Review of the Heron BESS Application Noise Study

Prepared: July 30, 2026
Project No. 2026-012

Review of the Heron BESS Application Noise Study

Figure 3: Anticipated Operational Noise Levels

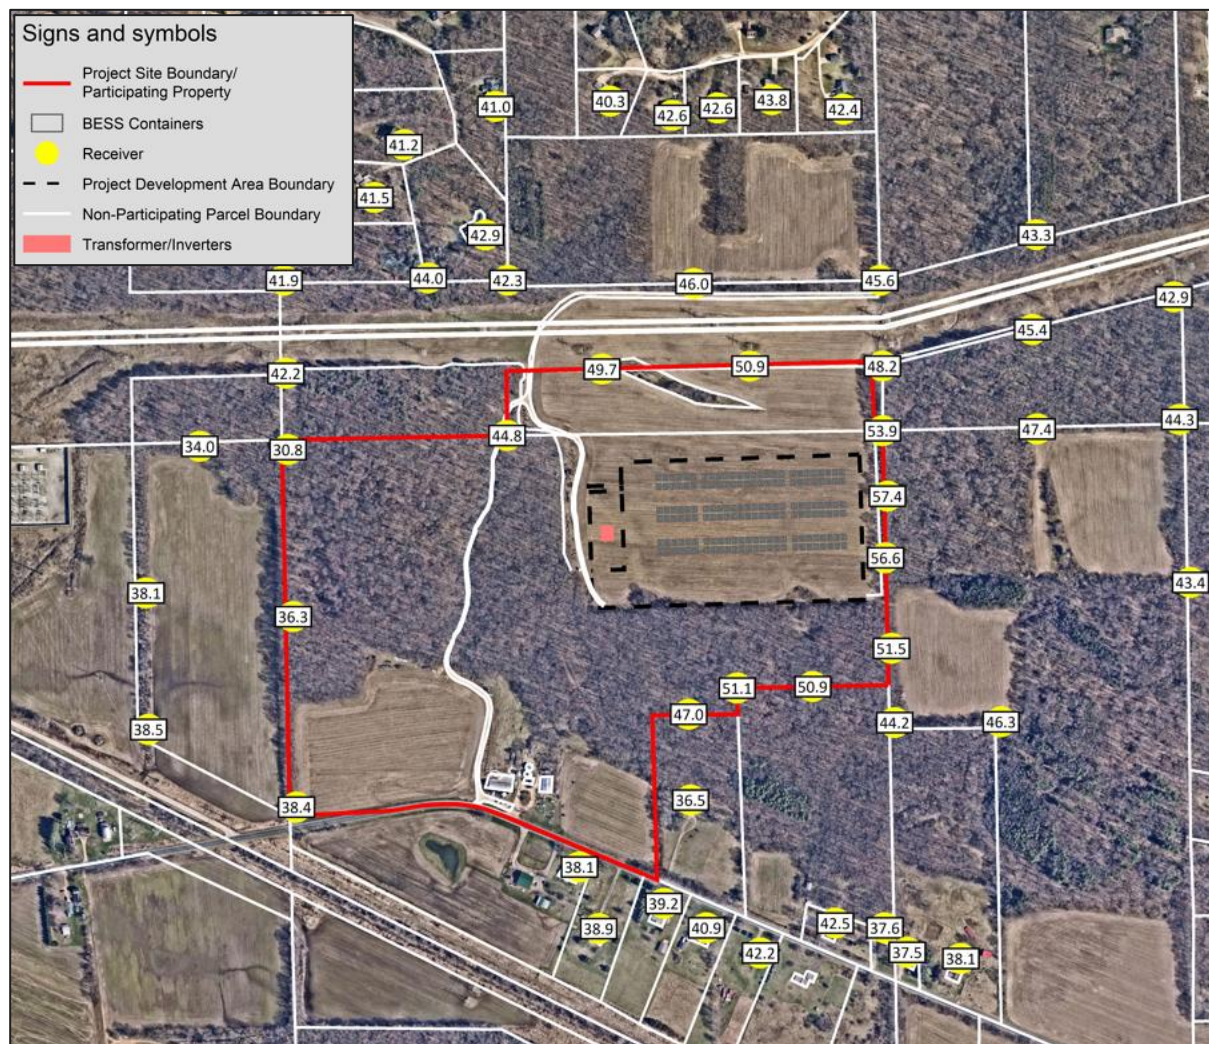
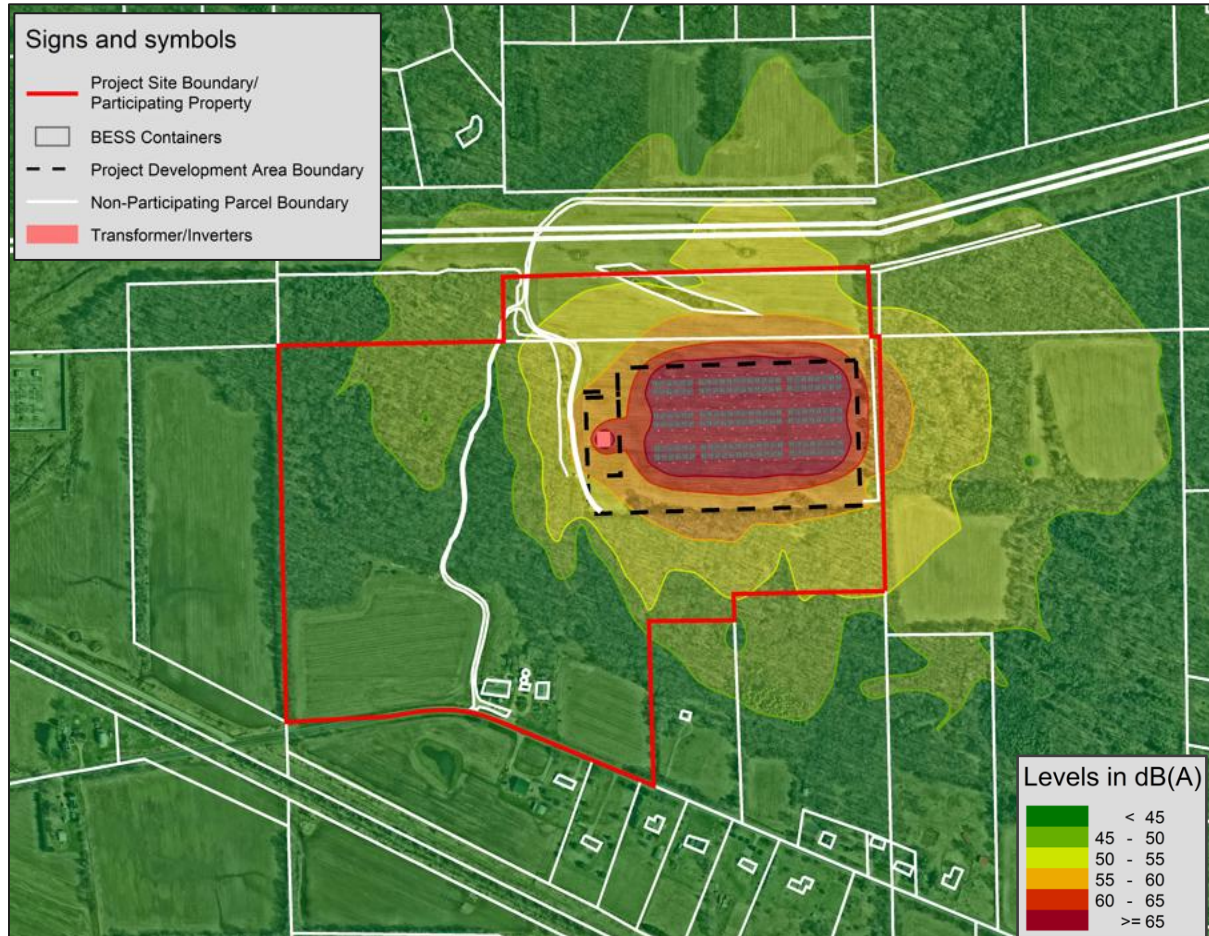
The report provides graphical results of the predictive modeling for the proposed BESS installation, showing both numeric sound levels and color contour mapping of the predicted sound levels. The Kimley-Horn modeling results indicate that maximum sound levels are predicted to be approximately 57 dB(A) at the east property boundary. At all other property boundaries, sound levels are predicted to be less than 55 dB(A).

The transformer's sound power level, based on our independent calculations, appears understated by approximately 7 to 10 dB(A) relative to what would be expected for a unit of this size and rating. Errors of this magnitude in the underlying source terms are not minor. They compound in a direction that understates the cumulative sound level predicted at the nearest non-participating property boundaries, including the 57 dB(A) maximum level reported at the east property boundary, and the design basis for the proposed sound barrier wall.

Figure 5: Anticipated Operational Noise Levels with Wall

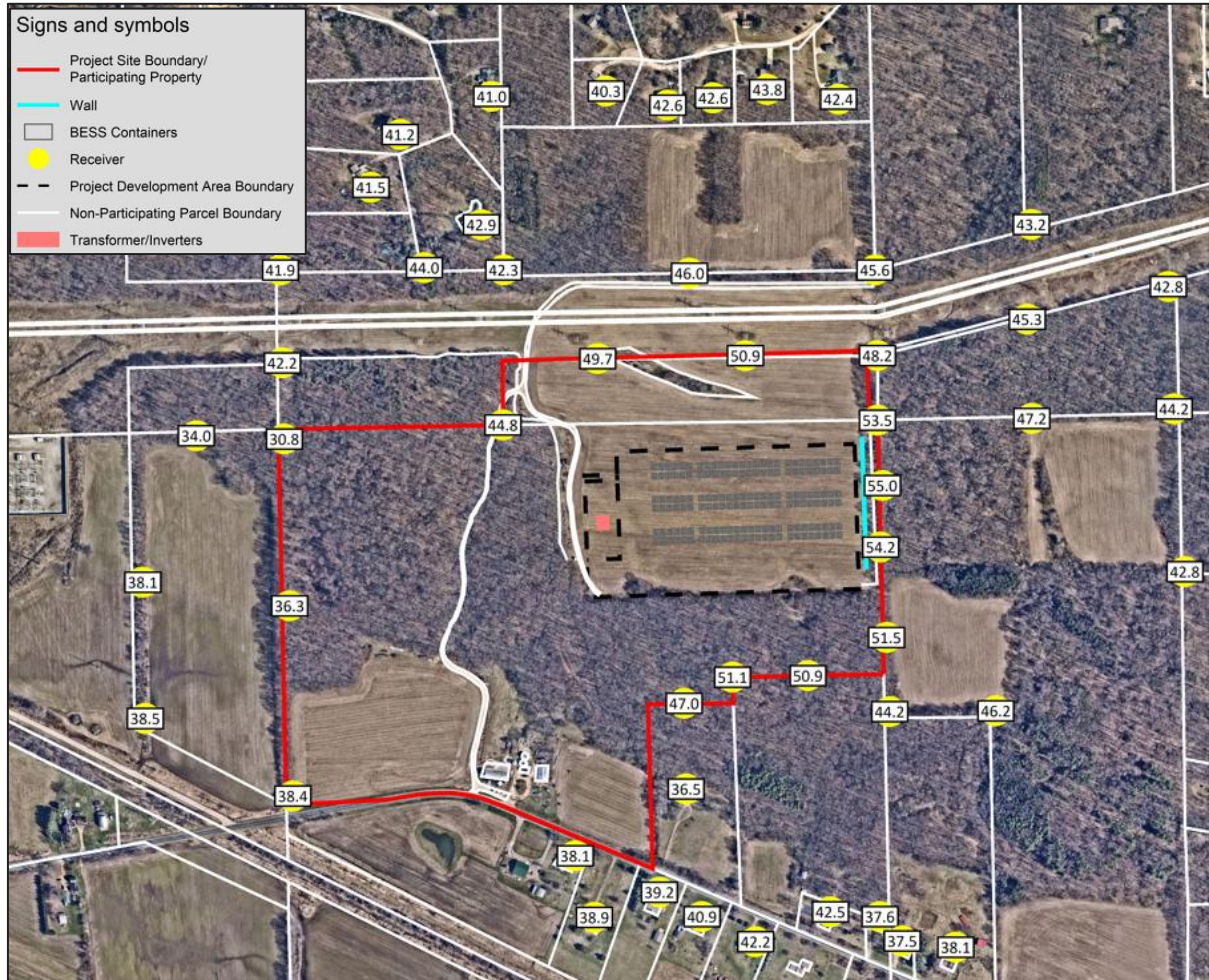
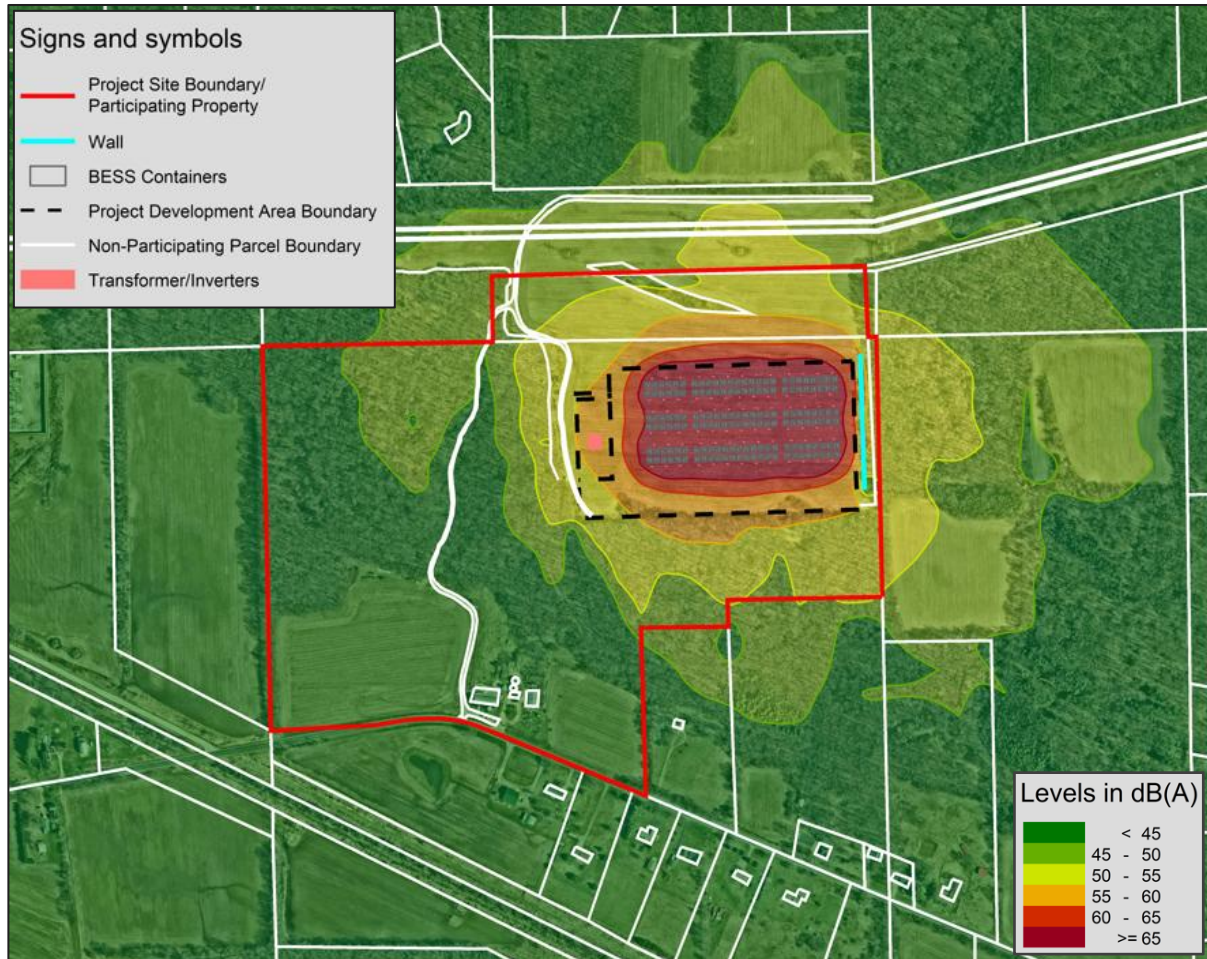
The report states that a 10-foot-tall, 600-foot-long reflective sound barrier wall with an "STC of at least 40" will be needed along the east property boundary to "...reduce on-site operational noise levels to be near or below the established sound limit..." Additional graphical results are provided showing that, with the sound barrier wall in place, noise levels at the east property boundary are predicted to be less than 55 dB(A).

Given these findings, we do not believe the noise study, in its current form, provides an adequate basis to confirm that the proposed Heron BESS facility will comply with the applicable noise ordinance at the nearest non-participating property boundaries. We recommend that the applicant's acoustical consultant revise the inverter and transformer source characterizations using properly substantiated sound power data and appropriate spectral information. Also, documentation of the source type, elevation, structural modeling, and reflection settings used for each noise source should be included. The design of the proposed sound barrier wall should be reassessed accordingly, noting that its current STC-based specification is used for indoor partition sound isolation specification and is not consistent with outdoor noise barrier attenuation performance.
